*Staff Report – December 13, 2021 (Continuation)
November 22, 2021 (Public Hearing)*

SP-04-38M1 Special Permit Modification-Restaurant
Modify Floor Plan, Site Plan, and Signage
2378-2390 James Street
Palace on James, LLC (owner)
Katrina Skinner (applicant)
Business, Class A, Residential, Class A-1, James Street Overlay District

PROJECT NO
DRAWN BY DGD
CHECKED BY
DATE 16 OCT 2021
SCALE AS NOTED
TITLE OVERALL FLOOR PLANS 8.5"x11" SHEET
SHEET NO 1 of 2

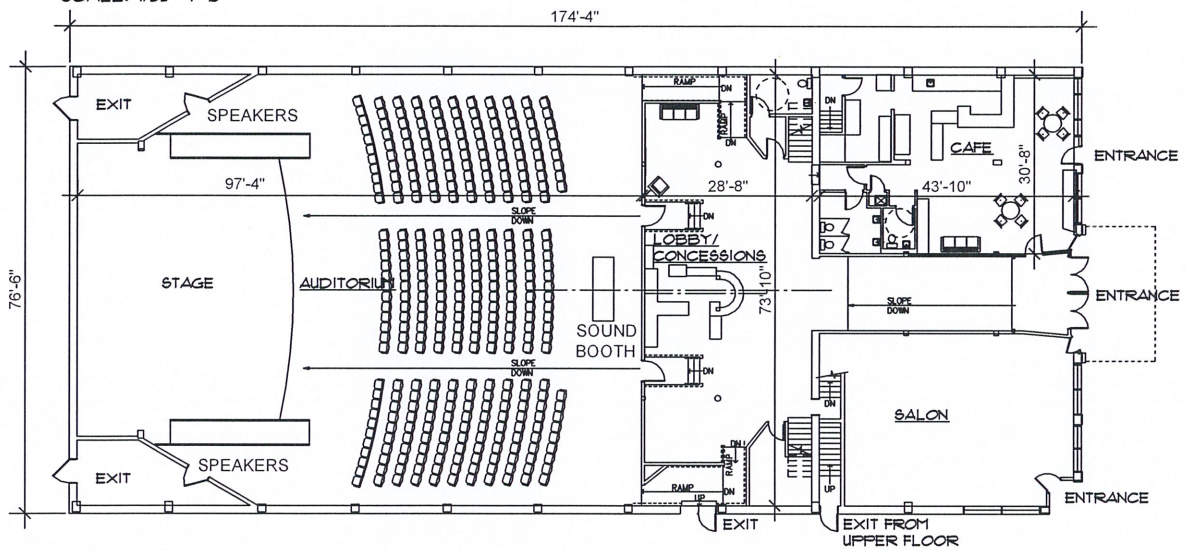
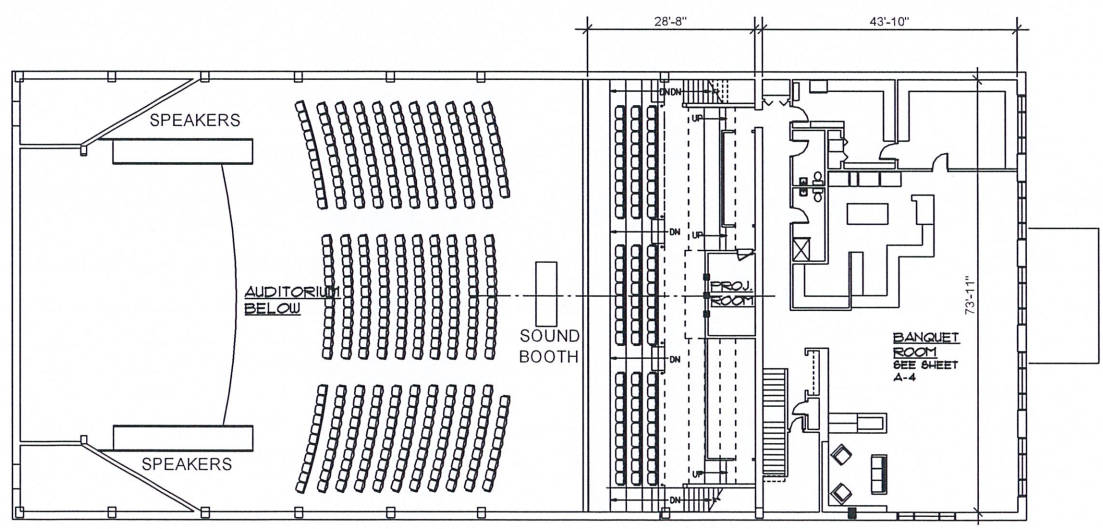
- 20) The applicant submitted **overall floor plans** (Sheet 1 of 2) dated October 16, 2021, which **illustrate existing land uses** consisting of an existing café, a salon, a theater, and a banquet room.

TITLE
**CAFE
 PLAN
 8.5"x11"
 SHEET**

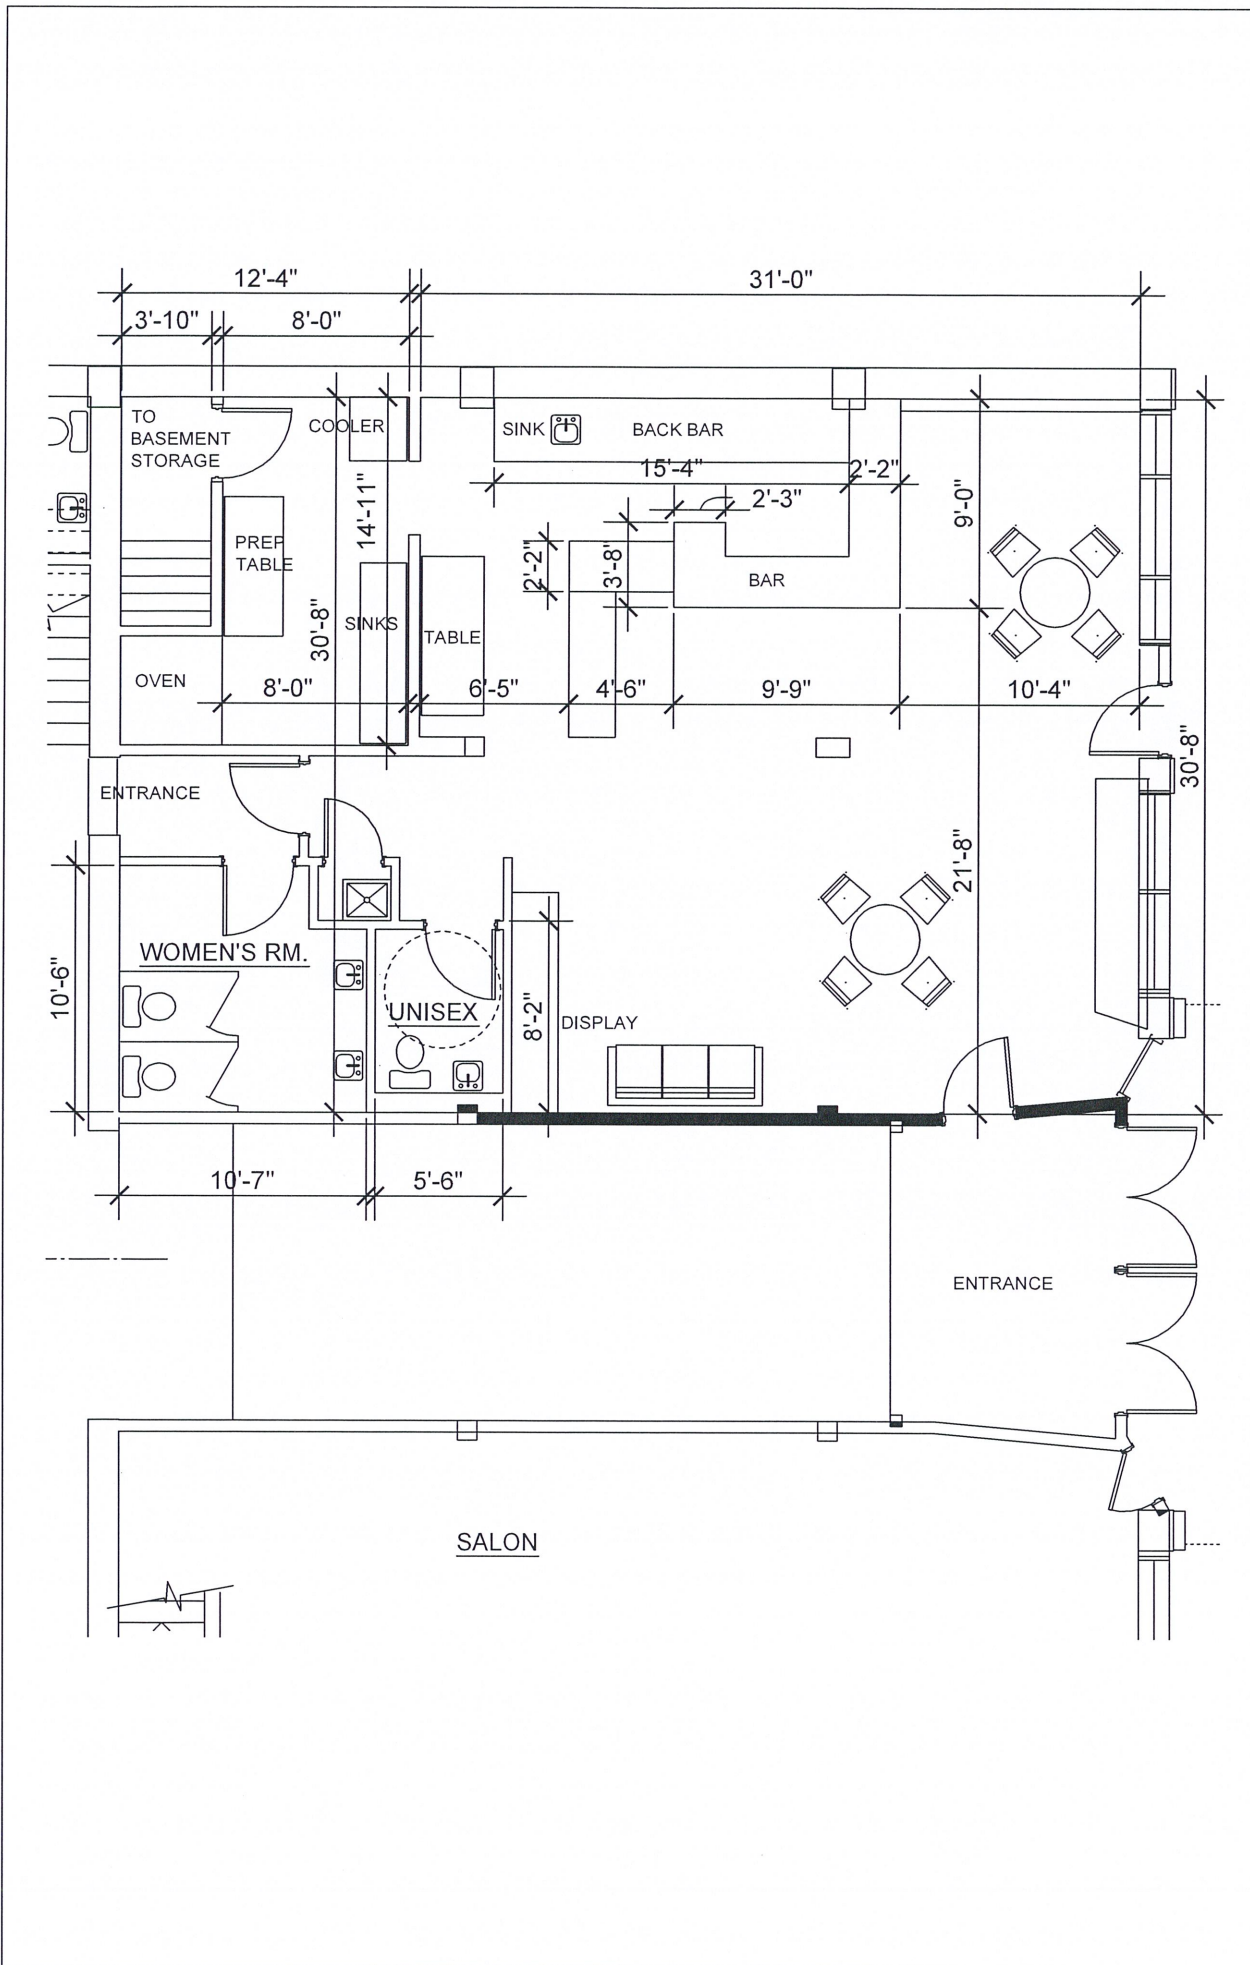
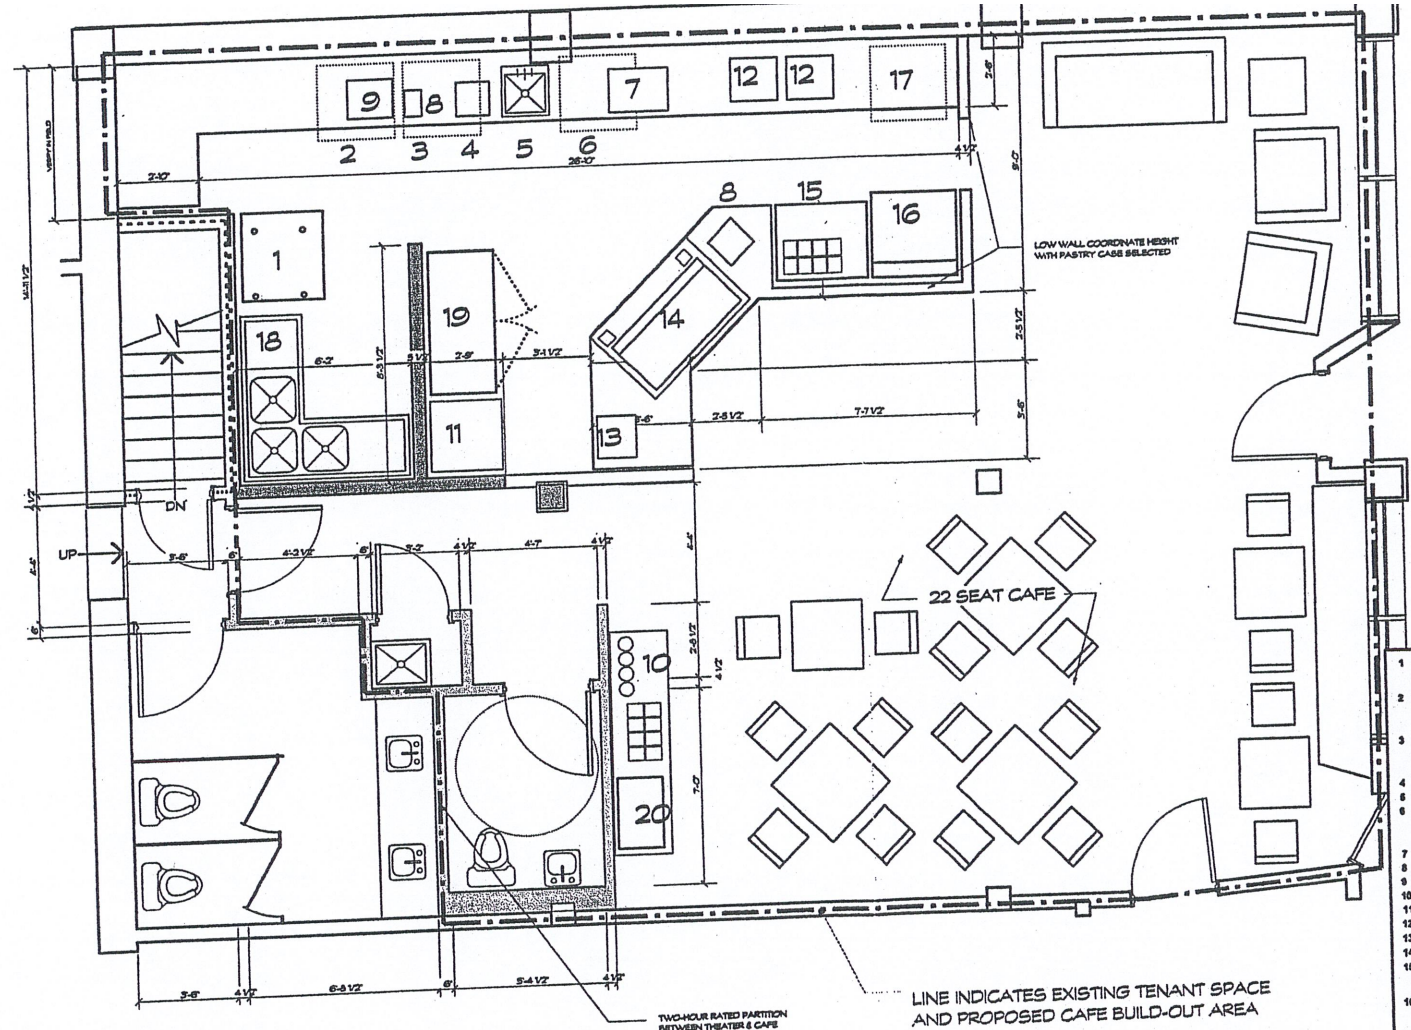
- 21) The applicant submitted a **floor plan for the restaurant** (Sheet A2 of 2) dated October 16, 2021, which **illustrates** the existing **café with approximately 21 feet of façade frontage** and a **customer area of approximately 620 square feet**. The proposal increases the customer area of the restaurant by 120 square feet, thus **increasing the off-street parking requirement by four spaces**.
